<b>Title - Sujet</b> Indoor & Outdoor walk-in Freezer-Re	
<b>Solicitation No. - N° de l'invitation</b> 21120-133422/A	<b>Amendment No. - N° modif.</b> 010
<b>Client Reference No. - N° de référence du client</b> 21120-13-1913422	<b>Date</b> 2014-01-16
<b>GETS Reference No. - N° de référence de SEAG</b> PW-\$KIN-650-6189	
<b>File No. - N° de dossier</b> KIN-2-38306 (650)	<b>CCC No./N° CCC - FMS No./N° VME</b>
<b>Solicitation Closes - L'invitation prend fin</b> <b>at - à 02:00 PM</b> <b>on - le 2014-01-24</b>	<b>Time Zone</b> <b>Fuseau horaire</b> Eastern Standard Time EST
<b>F.O.B. - F.A.B.</b> <b>Plant-Usine:</b> <input type="checkbox"/> <b>Destination:</b> <input checked="" type="checkbox"/> <b>Other-Autre:</b> <input type="checkbox"/>	
<b>Address Enquiries to: - Adresser toutes questions à:</b> Rombough, Lori	<b>Buyer Id - Id de l'acheteur</b> kin650
<b>Telephone No. - N° de téléphone</b> (613) 545-8061 ( )	<b>FAX No. - N° de FAX</b> (613) 545-8067

**AMENDMENT #010**

The intent of this amendment is to answer potential bidders' questions & revise the Requirement.

**DELETE – Drawing within BI F210**

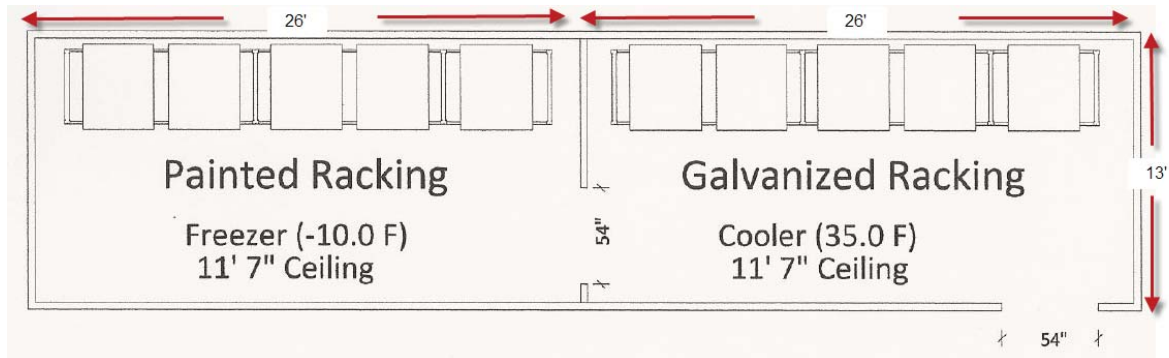
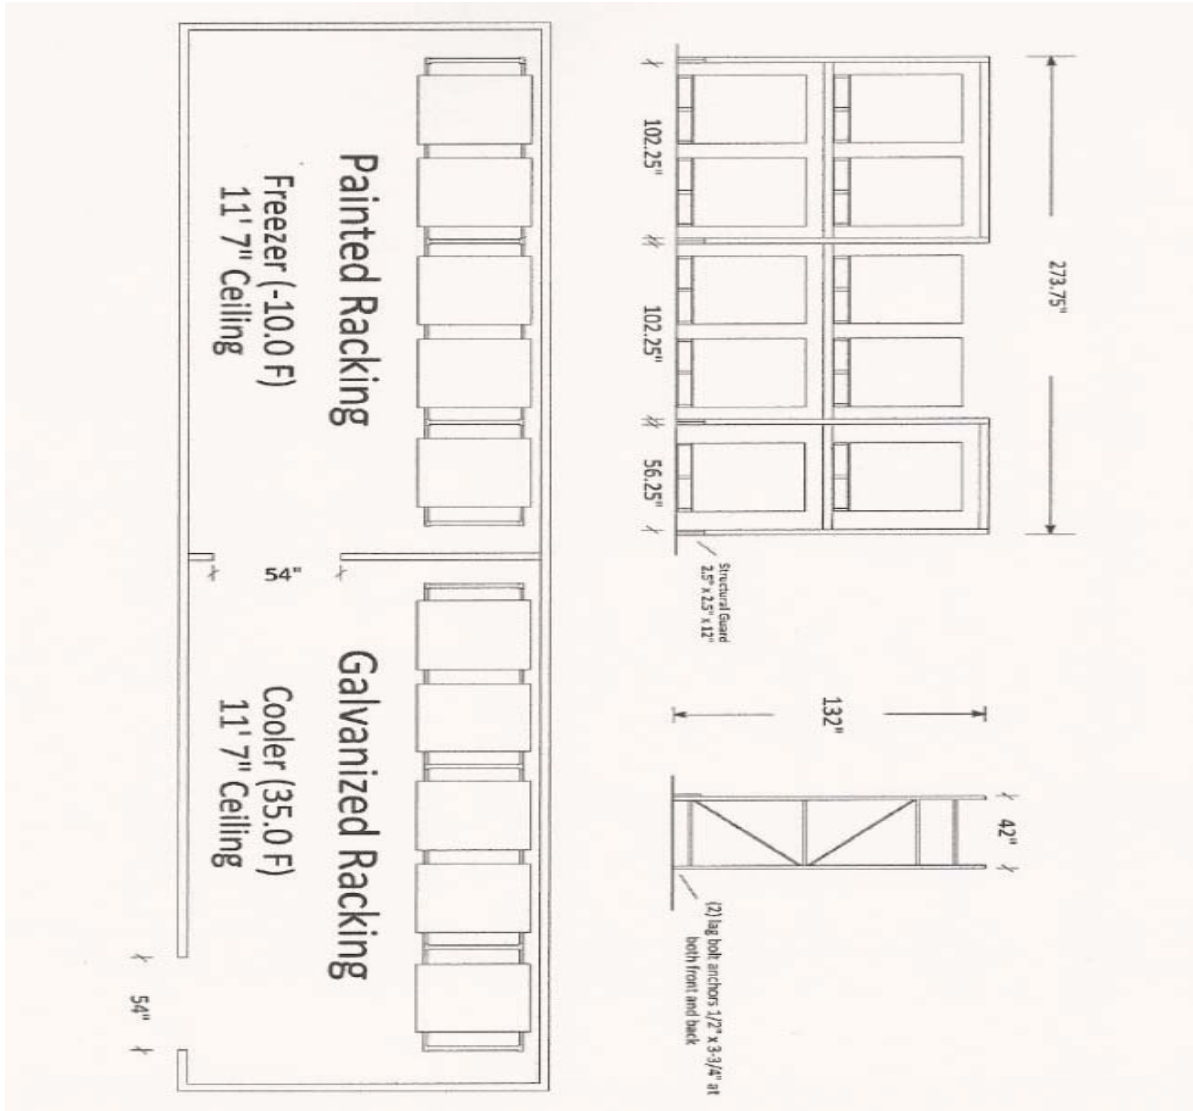
**NOTE TO BIDDERS: Additional information regarding Bath Institution Food Service Building – Outdoor Walk-in Cooler/Freezer Combination: #5 and 5a Bath Institution Drawing F210**

The racking systems, that will be purchased under a separate RFP, will positioned in the external freezer and fridge in the receiving area.

Please note that to allow for these racks, the positioning of the evaporator coil and doors will need to be adjusted accordingly.

**INSERT- Drawing**

Approximate location of racking
